[Docket No. NHTSA-2013-0076]

New Car Assessment Program (NCAP)

ACTION: Final decision.

Figure 1

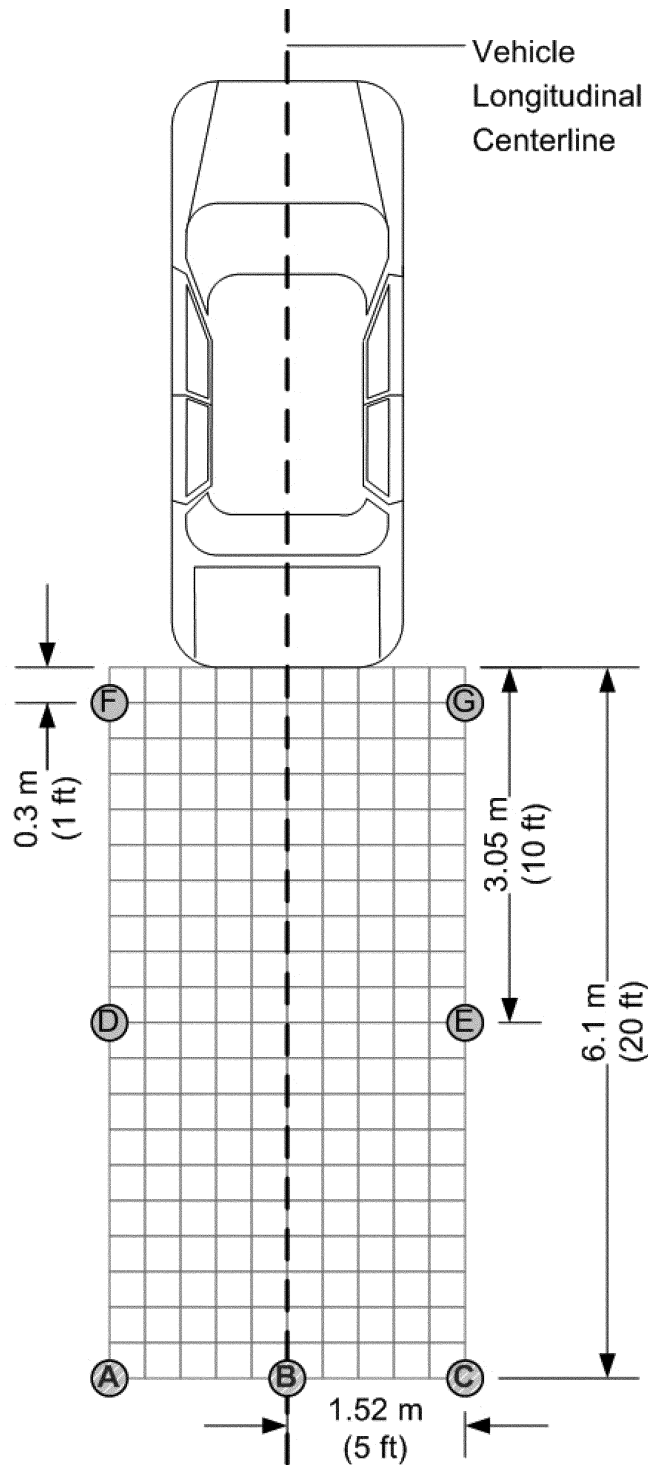
Certain manufacturers expressed two concerns with this test procedure to evaluate the field of view criterion. First, both the Alliance and Global Automakers assert that test objects F and G should be placed in a location that is proportional to the vehicle width (as opposed to 5 feet to the left and right

of the vehicle centerline). They contend that vehicles using a 130 degree camera would not cover the required portions of test objects F and G (in their current locations). Second, the Alliance stated that certain vehicles with a low rear height (i.e., a vehicle that is not high off the ground) has less height flexibility for

mounting a camera. Thus, the Alliance suggests that vehicles with an upper protected surface of the rearmost body structure of 750 mm or less be required to show only a minimum height of 0.4 meters (half the height) of test objects A through E (objects greater than 10 feet from the vehicle bumper).

We disagree with the manufacturers that this procedure for evaluating the field of view criterion does not accommodate vehicles with rearview video systems using a 130 degree camera or vehicles with a low rear height. When we originally developed this test procedure for the NPRM to amend FMVSS No. 111, we specifically designed this test procedure to be able to accommodate these types of vehicle designs. In response to the manufacturers' first concern, it seems clear that if we take into account three-dimensional nature of a camera's field of view, a 130 degree camera will cover the specified areas of all the test objects even if the vehicle has a low rear height. In tests conducted by the agency, the vast majority of vehicles equipped with rearview video systems were capable of meeting the field of view requirements as proposed in the NPRM.¹³ Thus, we are unaware of any camera that has a vertical angle limitation which would prevent it from easily being mounted at a pitch which covers the full height of test objects A through E.

In response to the manufacturers' second concern, we note that the portions of the F and G test objects that must be shown are measured by width only in order to accommodate vehicles of varying height and width. Thus, we disagree with the manufacturers that a 130-degree camera is unable to cover the width parameters for test objects F and G. We believe that the diagrams presented by the commenters regarding the inability of the 130-degree camera to cover test objects F and G fail to consider the three-dimensional properties of a camera's viewing angles. As Magna, a rearview video system manufacturer, stated in their comments to the NPRM to amend FMVSS No. 111, a 130-degree camera can readily cover the 5.9-inch (150-mm) width parameters of test objects F and G when mounting height and camera pitch is considered.¹⁴
